BELLEFONTE COMBINED LICENSE APPLICATION – STANDARDIZATION ERRATA  
REPORT REVISION 3

BELLEFONTE COMBINED LICENSE APPLICATION – RESPONSE TO REQUEST FOR  
ADDITIONAL INFORMATION – ONSITE METEOROLOGICAL MEASUREMENTS PROGRAMS

**NRC Letter Dated: August 4, 2008**  
**NRC Review of Final Safety Analysis Report**  
**NRC RAI NUMBER: 02.03.03-05**

FSAR Section 2.3 Appendix 2DD

Figure 2DD-204  
BLN Lower Level (10-m) Wind Direction

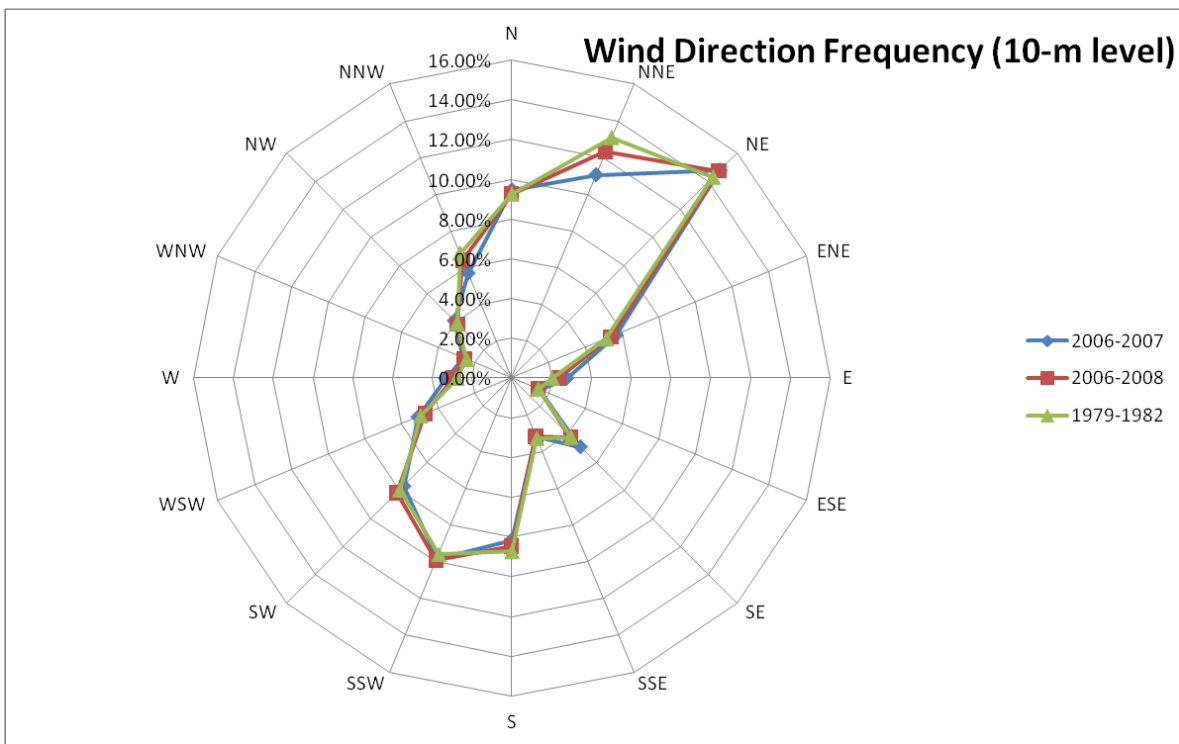
The NRC notified TVA that the wind rose figures (2DD-204 and -205), contained in the original response to this RAI, are not in accordance with typical direction oriented figures. They should be revised to match the compass headings, rather than alphabetically arranged.

TVA agrees with the NRC and is providing the attachment with the reoriented figures. No data has been changed.

COLA Part 2, FSAR, Chapter 2, will be revised to incorporate a new Appendix 2DD as provided in the original response and the replacement of the two reoriented figures.
